## ADDENDUM

**PROJECT:** South Dakota State University  
New Headhouse & Greenhouse  
Headhouse Shell Package  
Brookings, South Dakota

AD-1

**PROJECT #:** 12-0124 / OSE R0312-19X / SDSU 201202336

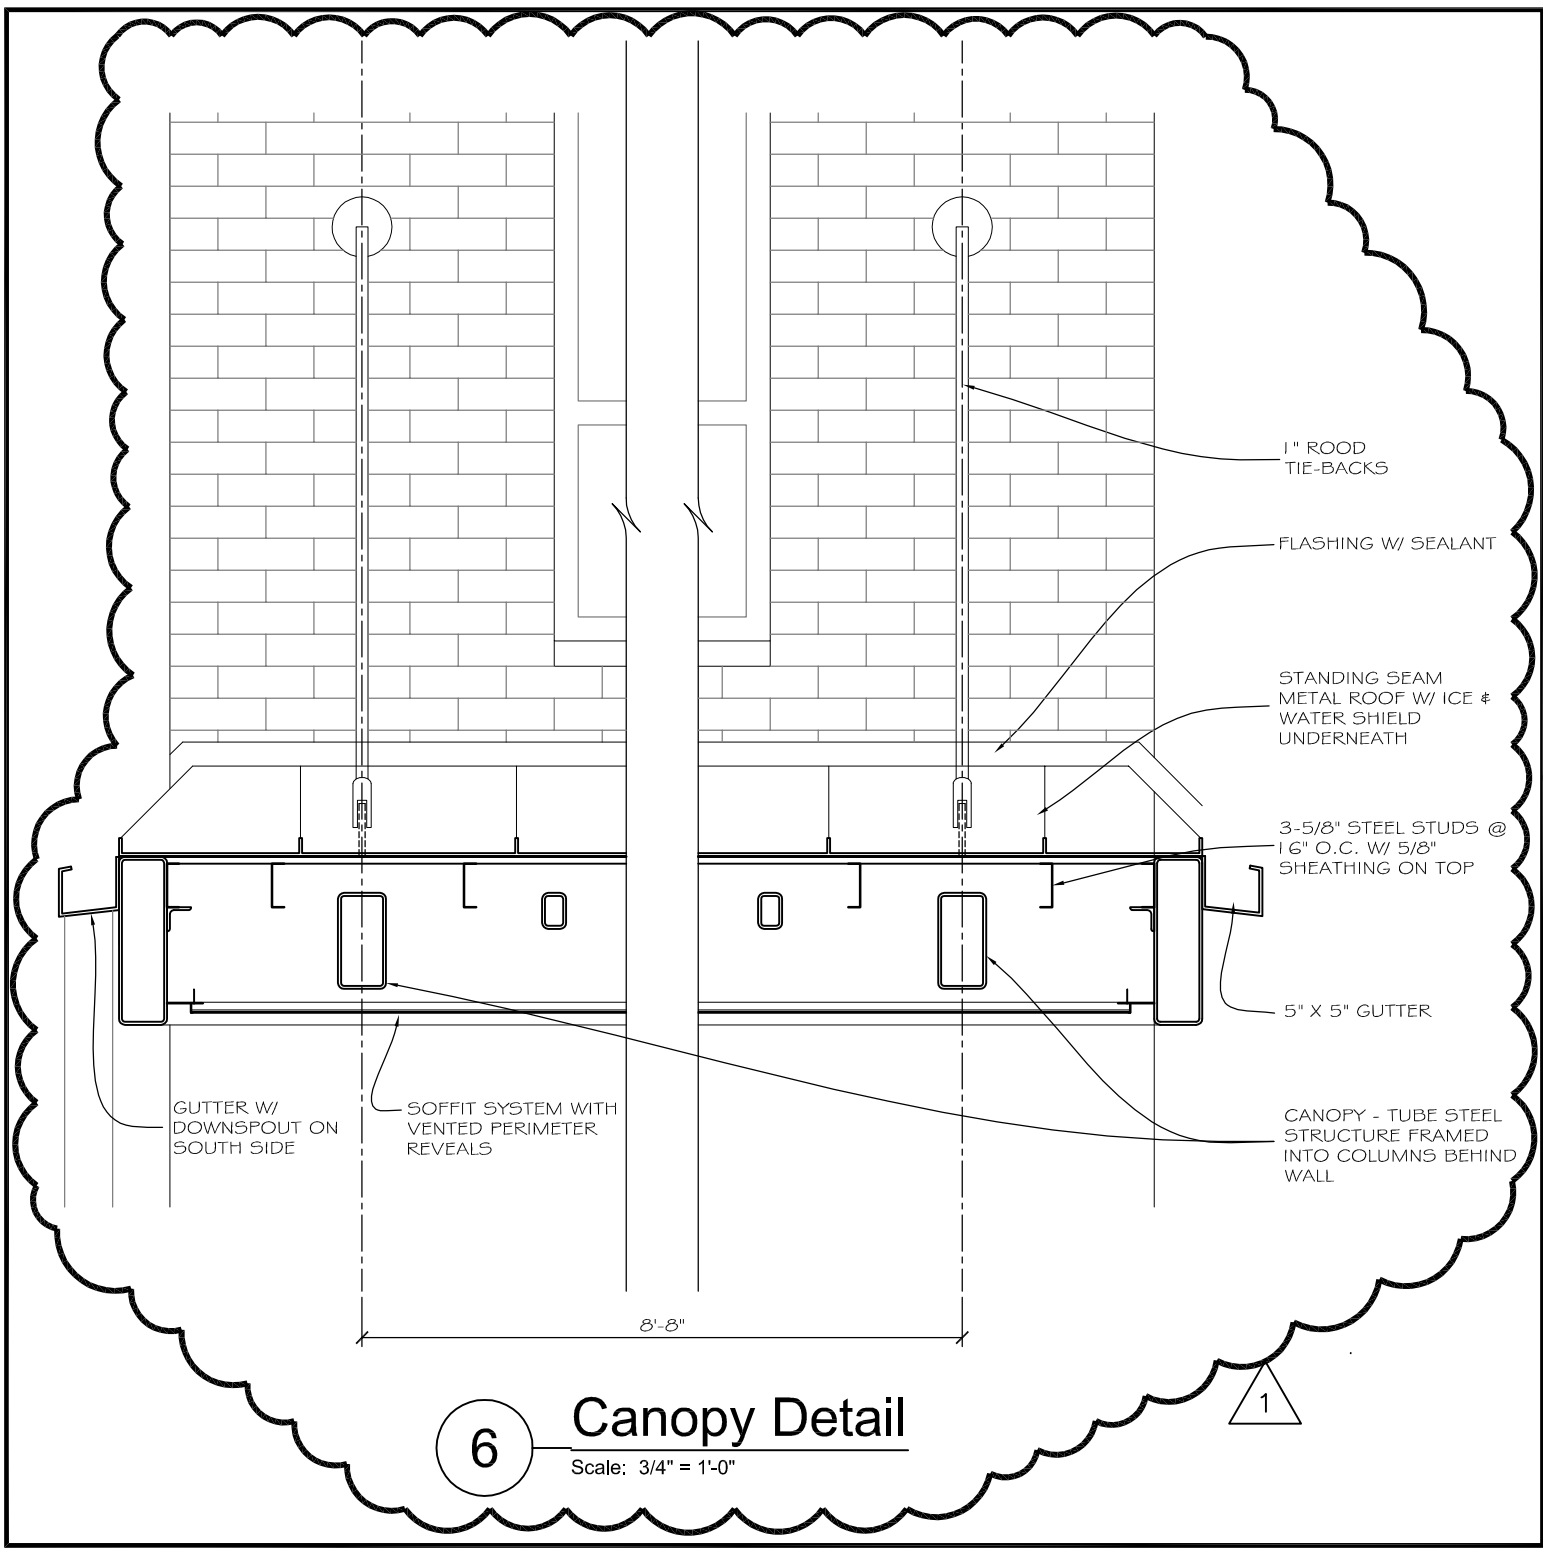
See attached 8.5" x 11" Supplemental Drawing A-303.4 showing changes to the roof canopy at Wall Section 5.

From Sheet: A-303	for CA use:
Drawing # A-303.5

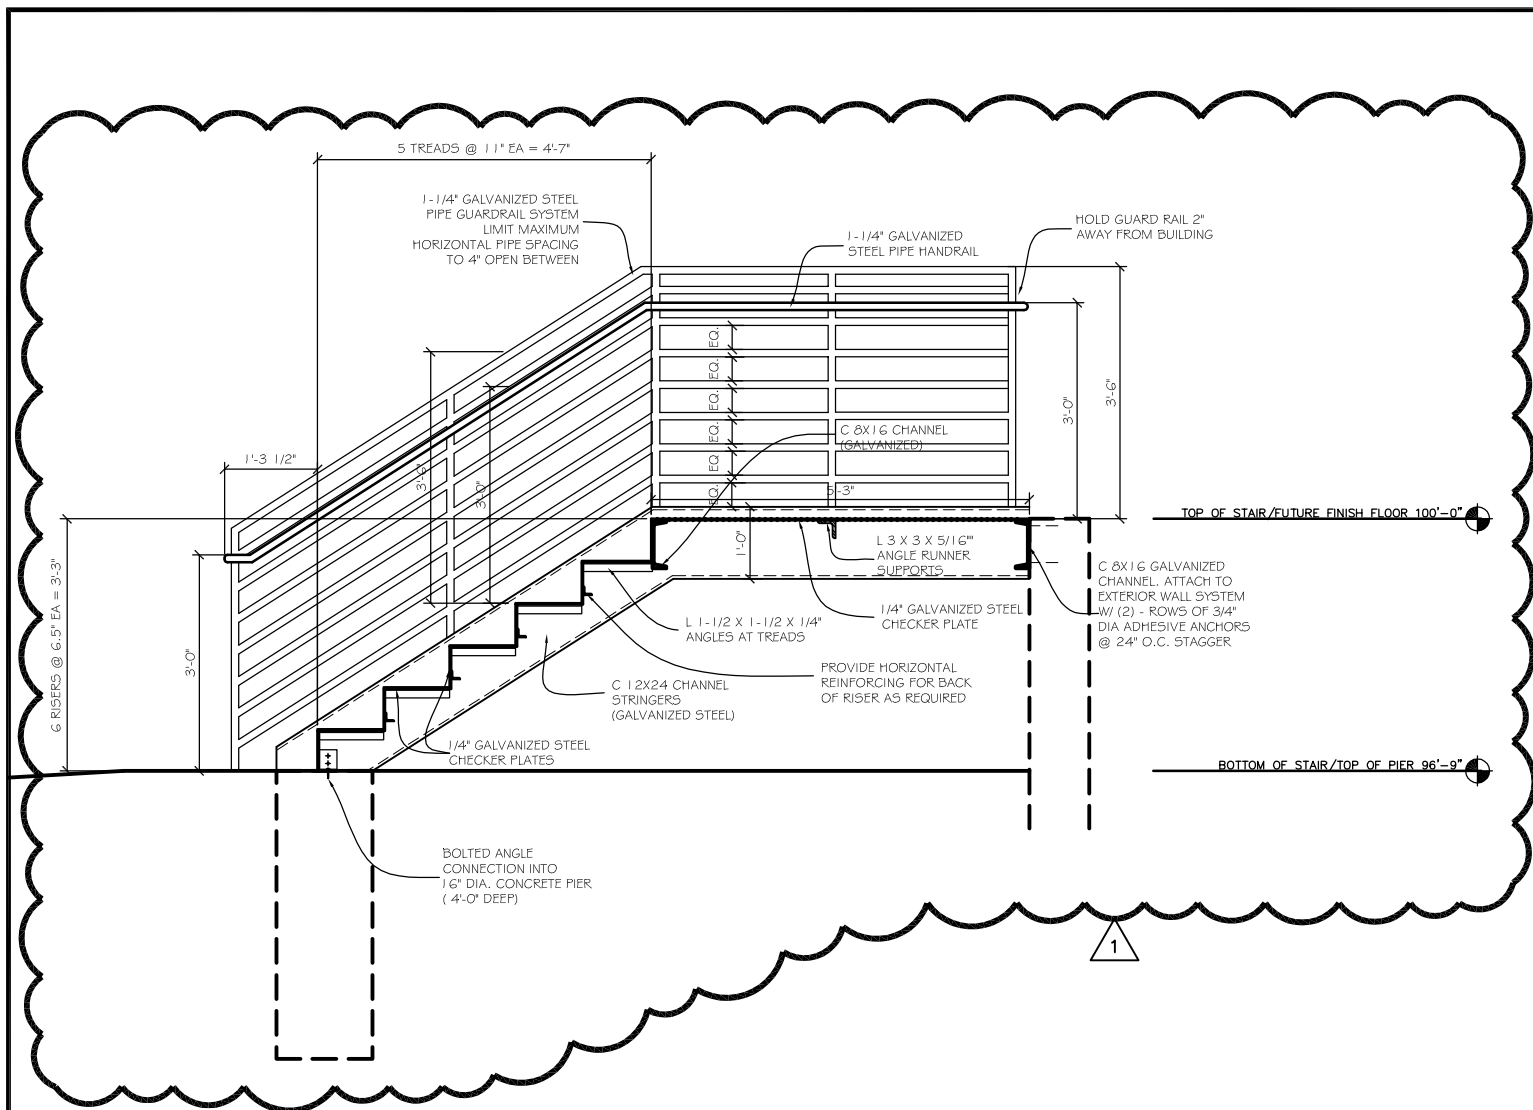
See attached 8.5" x 11" Supplemental Drawing A-303.5 showing changes to the canopy at Detail 6.

From Sheet: A-304	for CA use:
Drawing # A-304.1

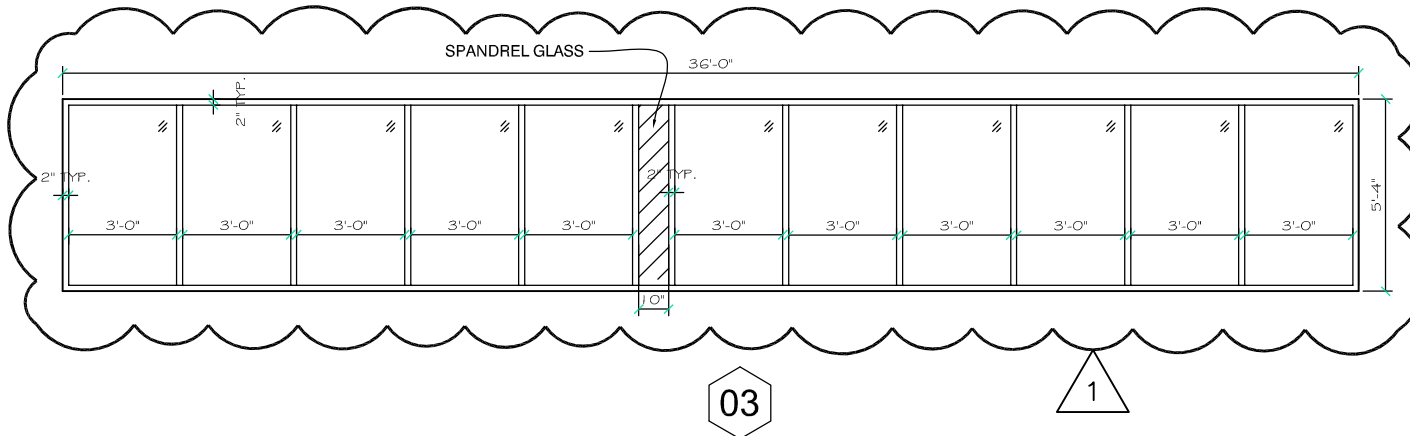
In reference to **Sheet A-304**, see attached 8.5" x 11" Supplemental Drawing A-304.1 showing revisions to Stair Section 3.

Drawing #  
A-601.1

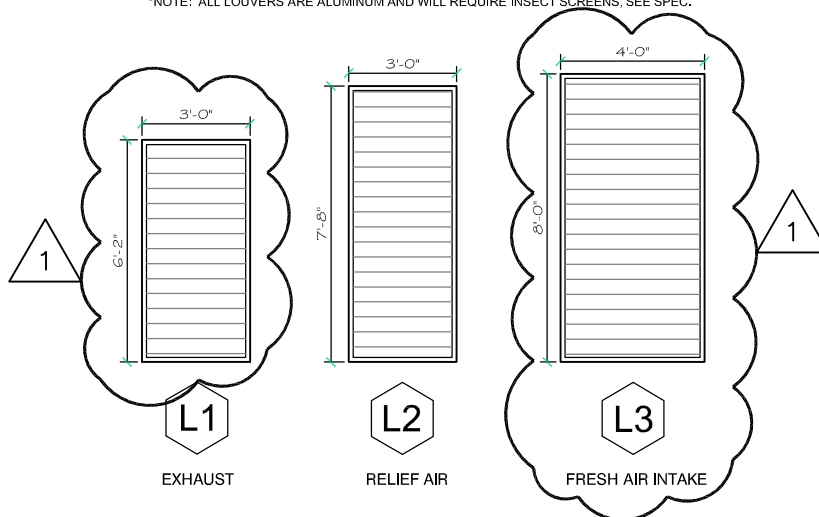
In reference to **Sheet A-601**, see attached 8.5" x 11" Supplemental Drawing A-601.1 showing revisions to the louvers and aluminum frame Elevation 03.

\*\*\*REPLACE ORIGINAL L3'S WITH L1. UPDATE THE OVERALL DIMENSIONS FOR L1'S. ORIGINAL L4 IS NOW L3. NO CHANGE TO L2.
